Service Manual

PERSONAL FACSIMILE

KX-FT34BR
KX-FT34BR2
KX-FT34BR-G
KX-FT34BR2-G
KX-FT34HK

Subject : Parts Change

1.2.1. KX-FT34BR, KX-FT34BR2, KX-FT34BR-G, KX-FT34BR2-G

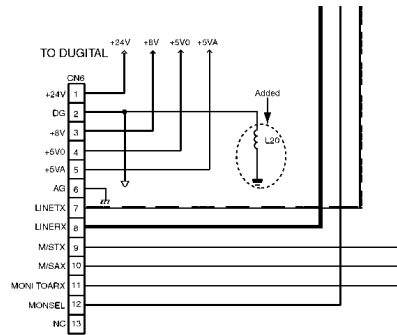
Ref No.	Part No.		Part Name & Descriptions	Pcs	Remarks	Notes		Time of change (Suffix)
	Original Part No.	New Part No.						
CABINET AND ELECTRICAL PARTS								
75	PFUS1091Z	PFUS1091Y	SPRING, STATIC ELECTRIC (A)	1	*a	1	V	
156	PFHX1031Z	PFHS1031Z	SHEET, BRAKE	1		7

Fig. 1

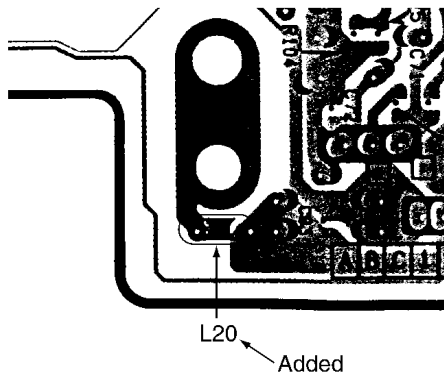
Ref No.	Part No.		Part Name & Descriptions	Pcs	Remarks	Notes		Time of change (Suffix)
	Original Part No.	New Part No.						
CABINET AND ELECTRICAL PARTS								
71	-----	PFGT1666Z-M	NAME PLATE	1		5		
75	PFUS1091Z	PFUS1091Y	SPRING, STATIC ELECTRIC (A)	1	*a	1	V	
156	PFHX1031Z	PFHS1031Z	SHEET, BRAKE	1		7		
ACCESSORIES AND PACKING MATERIALS								
P1	-----	PFPK1791Z-M	GIFT BOX	1		5		
ANALOG BOARD PARTS								
L20	-----	PQLQR1ET	COIL (FERRITE BEAD)	1	*b, Fig.1	5

Change from KX-FT33AL Original Service Manual Order No. KM79807220C3, page 158, section 6/F.
